**Review of Tube R2C5 in Steam Generator 24**

**Phase settings between 1997 and 2000**

Figure 1 C-scan with 1997 phase setting.

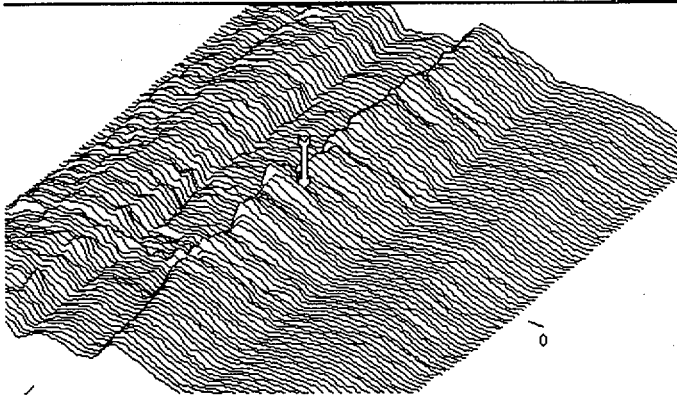
In 1997 the phase rotation for the eddy-current calibration was set too low, resulting in a decrease in the vertical signal that the analyst uses for screening for defects. In Figure 1 we show the c-scan plot with the phase set too low. In Figure 2 we show the phase setting that is being used for the current inspection. The indication, which is riding on a noise ridge, is easier to see.

Figure 2 C-scan with the 2000 phase setting.

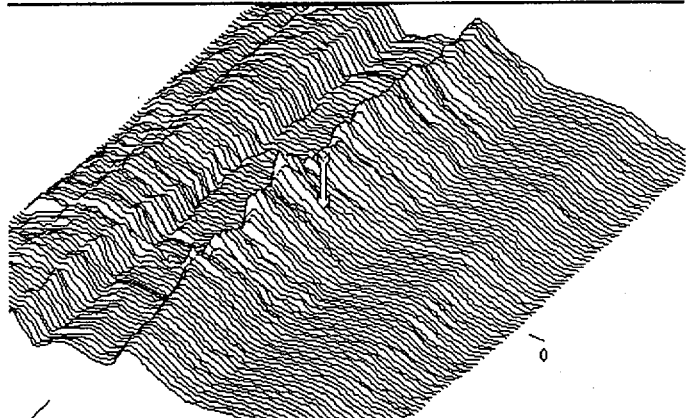
With proper training the analyst would be more likely to discover the indication with this phase setting. In Figure 3 we show the Lissajous of the indication that the arrow is pointed to.

Figure 5 Noise signal that runs the length of the u-bend.

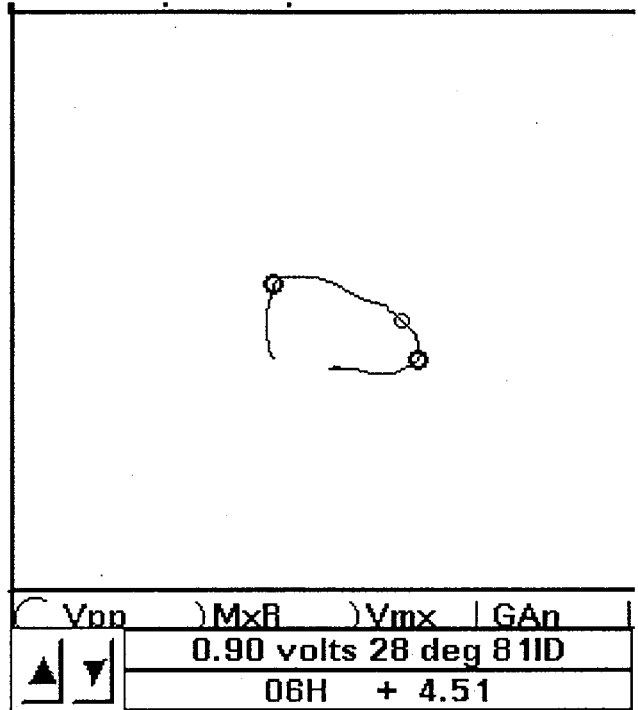
The defect signal sits on a noise ridge that runs the length of the tube. This noise ridge is about 1-volt in amplitude and measures as a deep id defect, on the order of 70 to 100% deep. This ridge makes both the detection and sizing of this defect more difficult. In Figure 5 we show the lissajous of the noise ridge. The signal-to-noise is slightly better for the 400 kHz frequency than the 300 kHz.

Figure 6 C-scan of the crack at 10 kHz

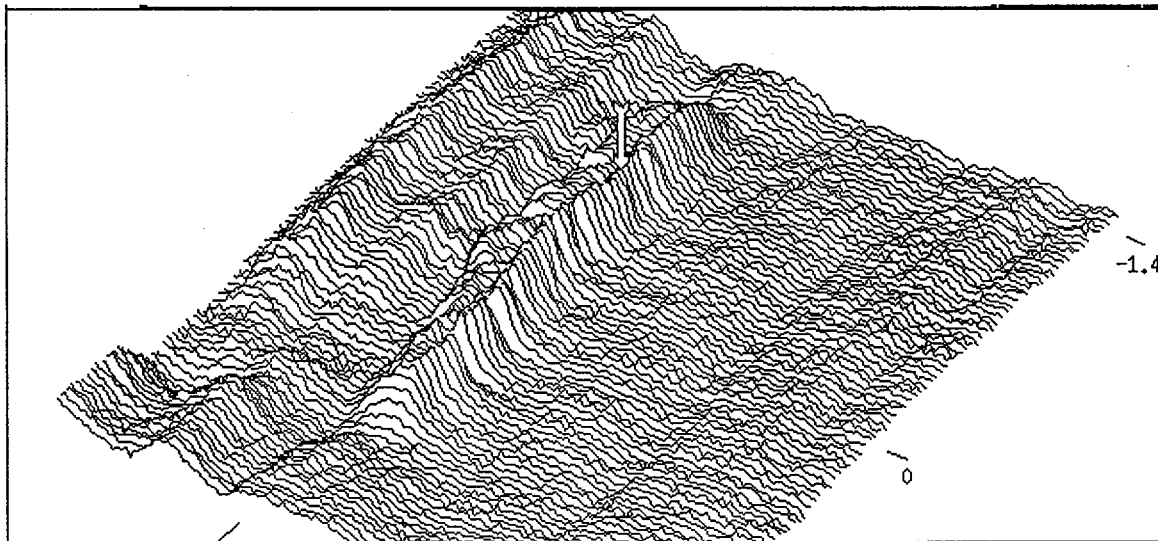
There is a signal on the 10 kHz channel that follows the defect. It is not known why the signal is visible at this frequency, although it may be due to a slight ferromagnetism of the crack. In Figure 6 we show the c-scan of the signal that has the same outlines as the crack. This scan also has signal-to-noise problems. In some cases the analyst will remove any indication from the defective tubing list if a

**Figure 7** Contour of the crack in tube R2C5 in SG24 using the 1997 data from the mid-range plus-point probe.

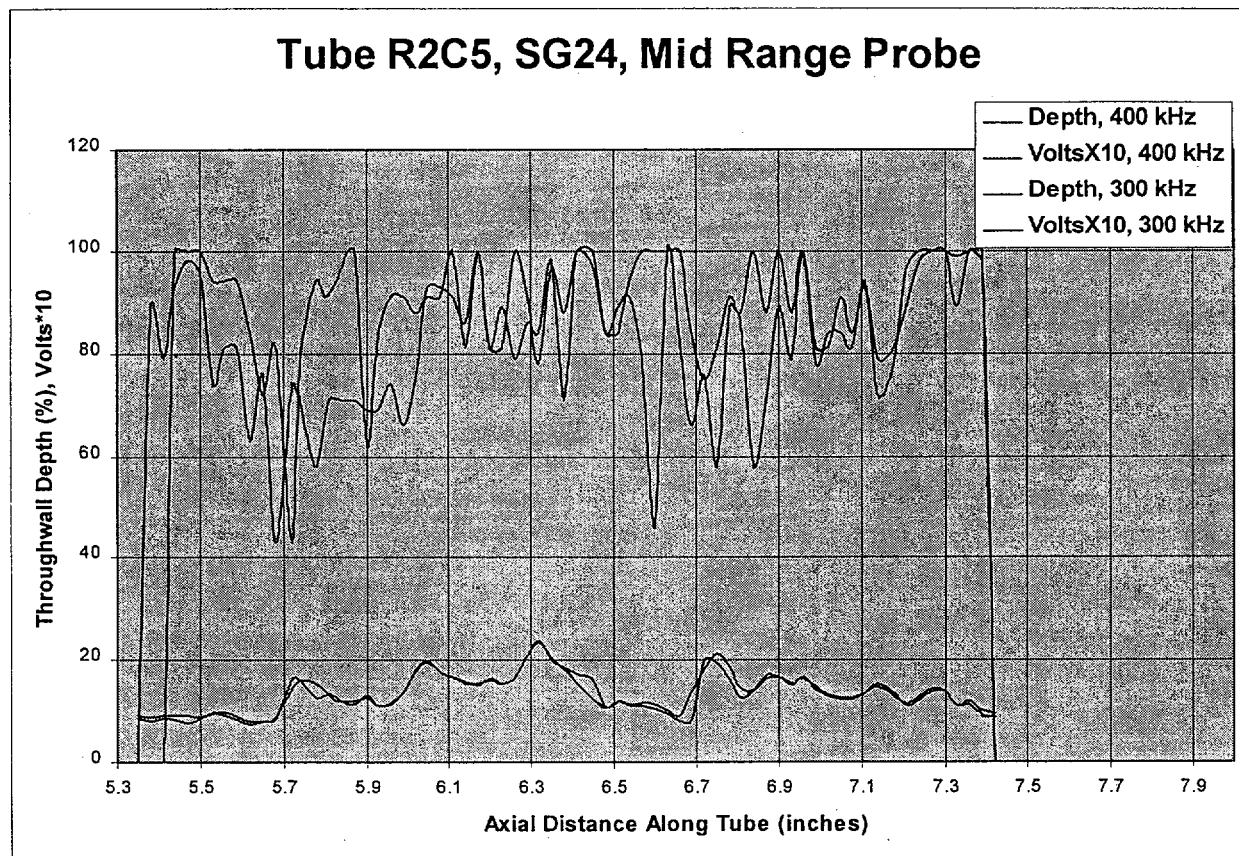
The indication has been profiled for both frequencies, as is shown in Figure 7. The 400kHz profile is probably slightly more accurate than the 300 kHz profile. Neither is very accurate, and until the defect voltage increases above 1.2-volts, there is considerable error. This can be

contrasted to the 0.4-volt threshold for the high-frequency probe. No attempt has been made to adjust these profiles for the end effects of the probe.

**Figure 8** C-scan of tube r2c5 of steam generator 24 using the circumferential line filter.

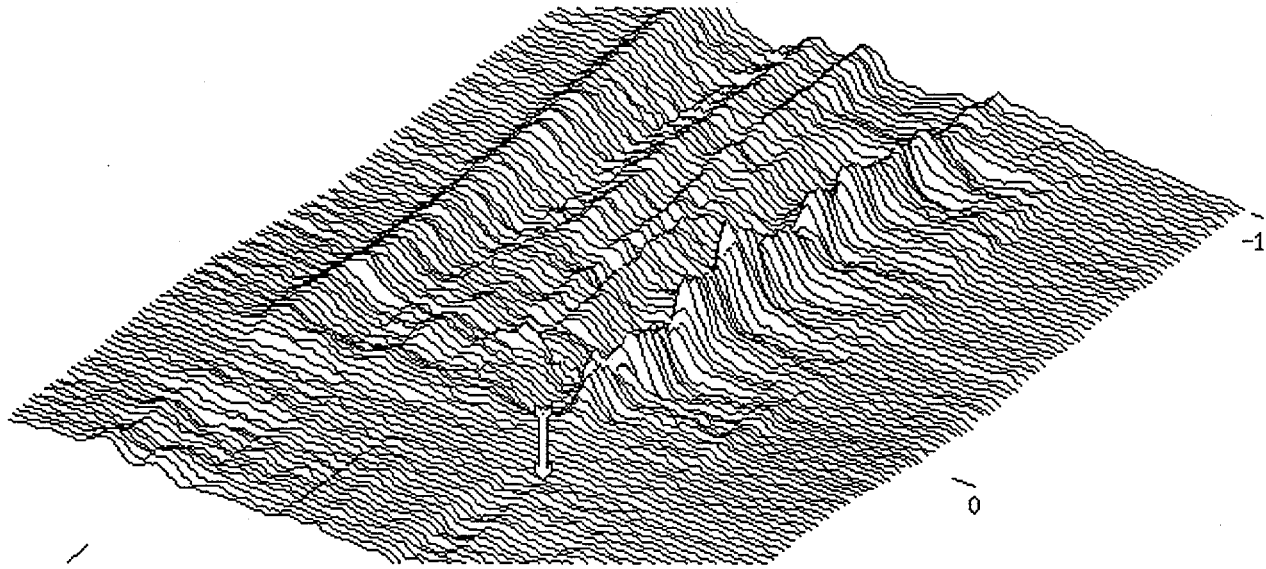
The Zetec software (and I believe also the Anser software) has the ability to subtract an average signal or a single line signal from both the axial and circumferential c-scan plots. The main use of these “filters” is for cases like this where you need to separate a defect from other naturally occurring signals with relatively constant shapes, such as tube supports or these ridges. A number of different processing methods are referred to as filters, including this type of simple subtraction filter and frequency filters. Westinghouse discourages the use of filters in general since they throw away some of the signal that may contain a defect. The analyst guidelines state that the analyst does have the option of using filters, but it is not mandatory. In Figure 8 we show a C-scan of the R2C5 using the circumferential line filter. We are subtracting the signal from a single circumferential line set at the location of the arrow. The defect is easier to see at this location. The signal from the ridges cancels out near the location that we set the line filter,

but, due to the variation of the axial ridges with distance along the tube, it reappears a short distance away. However, the defect signal is displayed in a form easier to recognize. This scan can be compared to the scan in Figure 2 with the line filter off. This method can be used as a tool to help the analyst, but it also does not do as good a job of eliminating the noise signals as the high-frequency probe. It is hard to use the filters and do a profile of the tube since the filters turns off when the next line scan button is pushed.
